### **SERVICE BULLETIN**

Subject: Transmittal of Revision 1 to Service Bulletin Number V2500-NAC-71-0010

V2500-NAC-71-0010

NACELLE – POWERPLANT – IDG CABLES - 400VC-A CONNECTOR – PRESSURE SPRINGS – INSTALLATION OF

Location of the 400VC-A Connector Figure 1, sheet 1

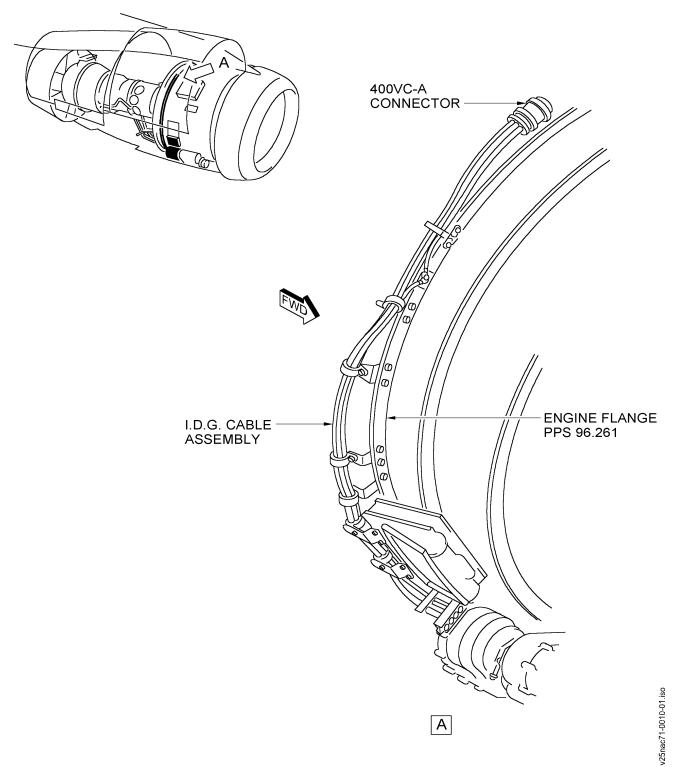
- (1) Open the right Fan Cowl Door as specified in the Engine Maintenance Manual, Task 71-13-00-010-010.
- (2) Find the 400VC-A Electrical Connector on the IDG Cable Assembly at the right side of the Engine Fancase. Disconnect the 400VC-A Electrical Connector. Refer to Figure 1.

- (1) Connect the 400VC-A Connector to the Pylon interface. Make sure the Connector is fully engaged (shown by the indicator on the Connector Body). Refer to Figure 1.
- (2) Close the right Fan Cowl Door as specified in the Engine Maintenance Manual, Task 71-13-00-410-010.
- (3) Do an operational test of the IDG electrical system as specified in the Engine Maintenance Manual, Task 71-00-00-700-012.

Figure 1, sheet 2 Preparation of the Sockets for installation of the Pressure Springs v25nac71-0010-02.iso

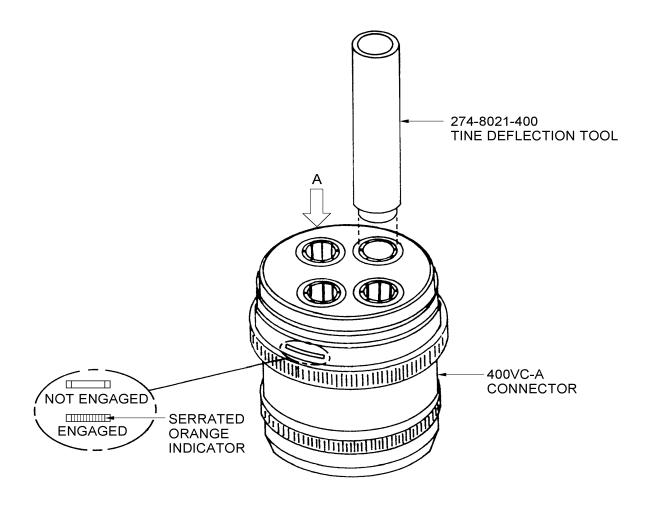
- (1) Carefully align the 274-8021-400 Tine Deflection Tool with one of the socket contacts, as shown in Figure 1. Push the Tool down into the socket contact to engage between the socket tines and the sleeve until it touches the bottom.

- (2) Remove the Tool and examine the clearance between the socket tines and the sleeve. If the clearance is less than .018" (0.46mm) do step (1) again.

Figure 1, sheet 3 Installation of the Pressure Springs

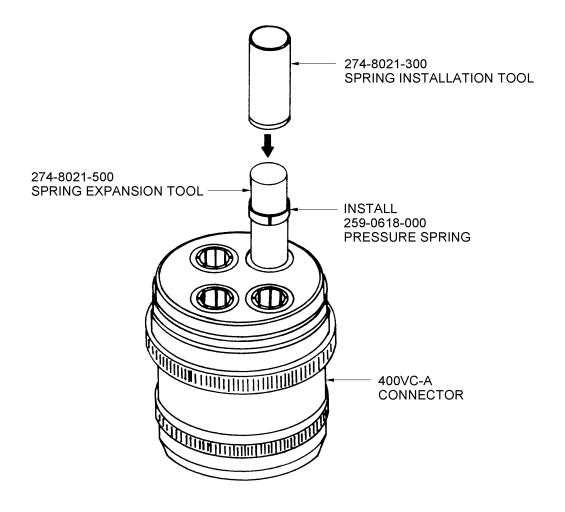
- (3) Manually put the 259-0618-000 Pressure Spring on the 274-8021-500 Spring Expansion Tool.
- (4) Put the small diameter end of the Spring Expansion Tool into the socket contact until it touches the bottom.

- (5) Put the 274-8021-300 Spring Installation Tool on the Spring Expansion Tool. Push the Spring Installation Tool down until it touches the Pressure Spring. Then push the tool down until it touches the top of the inner Spring Expansion Tool. You will hear a click as the Pressure Spring is installed in position.

- (6) Do steps (1) thru (5) again for remaining three socket contacts.
- (7) Re-identify the 740-5869-503 Cable Assembly to 740-5896-505.
